City of Richmond
Urban Development Division

**General Compliance
Request**

To: Development Permit Panel
From: Holger Burke
Acting Manager, Development Applications
Date: March 4, 2004
File: DP 02-221259
Re: **Application by Ah Ten Holdings Ltd. for a General Compliance ruling at
6300 Birch Street**

That the revised plans be considered to be in General Compliance with Development Permit DP 02-221259 for a 97-unit townhouse development at 6300 Birch Street that generally covers the following changes:

Hard
Landscape
Plan
South Area

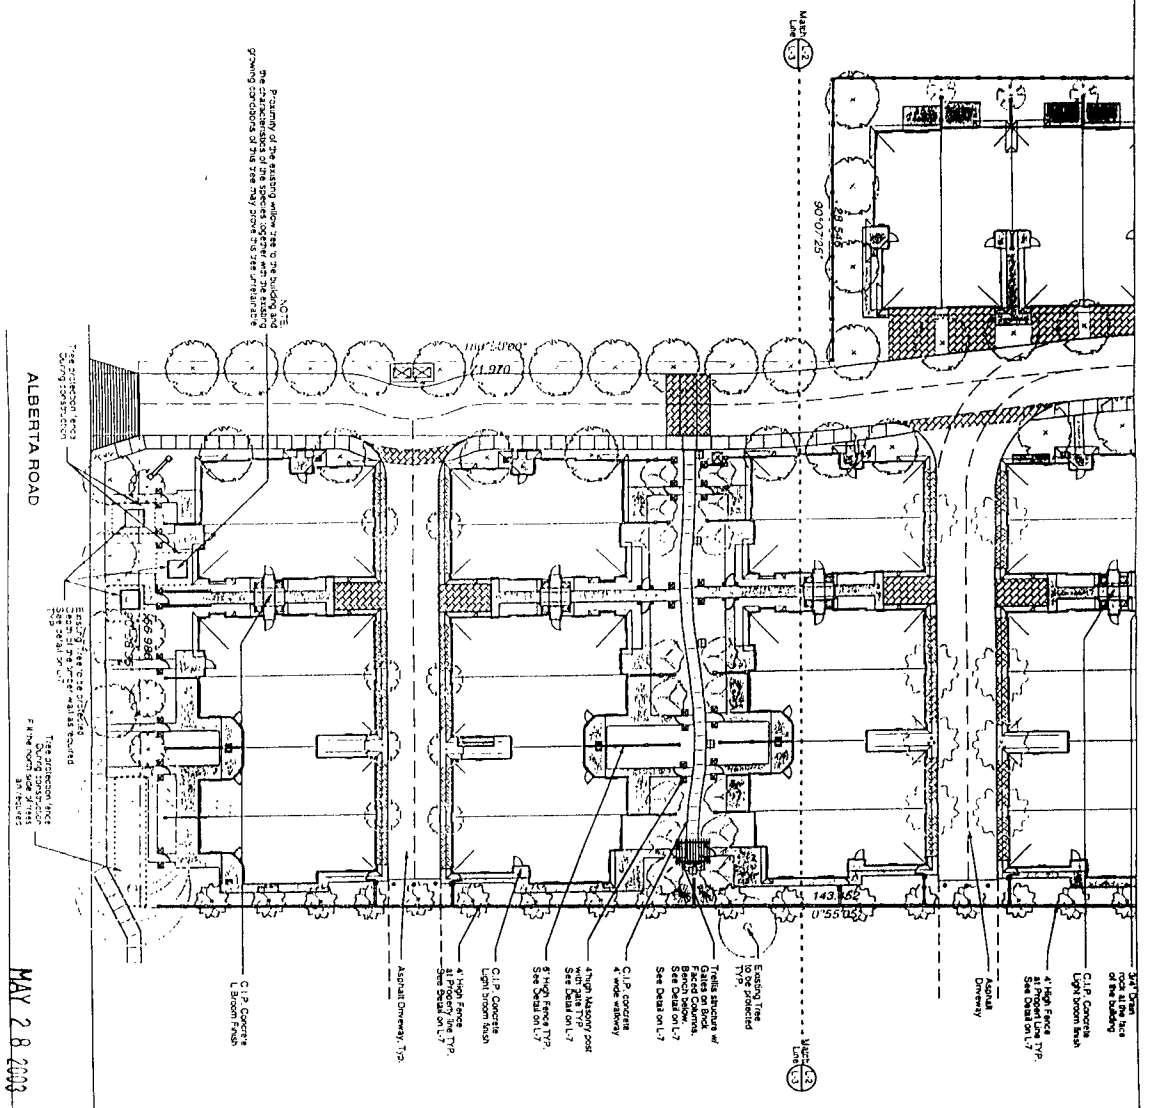
- ❑ Relocate a concrete walkway from the subject site located along the property line dividing the subject site and future Birch Park. This concrete walkway will be incorporated into the southern portion of the park (please see attached sketch).
- ❑ Add a concrete pillar (with brick façade) and metal rail fence (approximately 4-5 ft. in height) to enclose those backyards abutting the park. A gate is also being incorporated along the pathway leading into the park from the development site.

- ❑ ***The applicant is requesting that the concrete walkway bordering the site and park be relocated and incorporated into the park as a long 'arc' shaped pathway along southern portions of the park. City Parks Department staff have been consulted and have no objection to the above mentioned changes.***

TYPICAL ALUMINUM FENCE AND BRICK FACED CONCRETE PILLAR

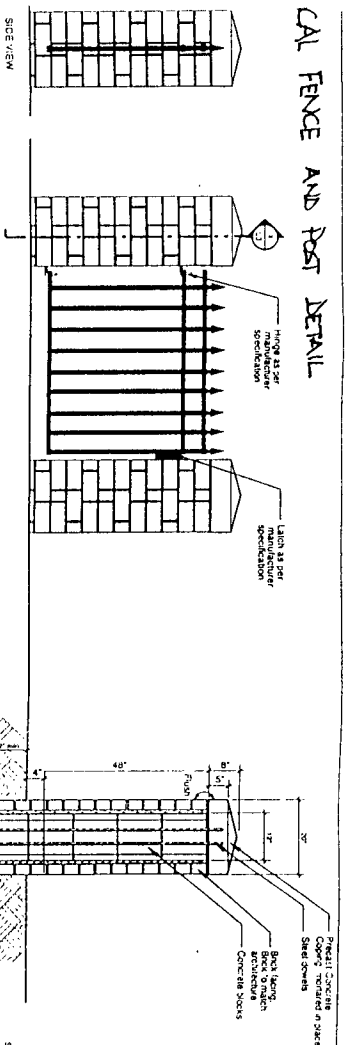
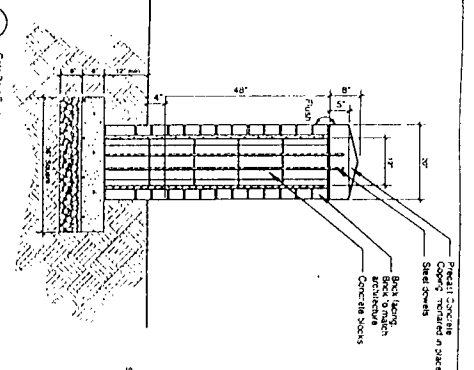
- ❑ Add a concrete pillar and metal rail fence (approximately 4-5 ft. in height) around backyard open spaces.

Implementation of a concrete pillar and metal rail fence to enclose the backyards is reasonable given that the design and height (approximately 4-5 ft.) is similar to fence detailing throughout the entire project.
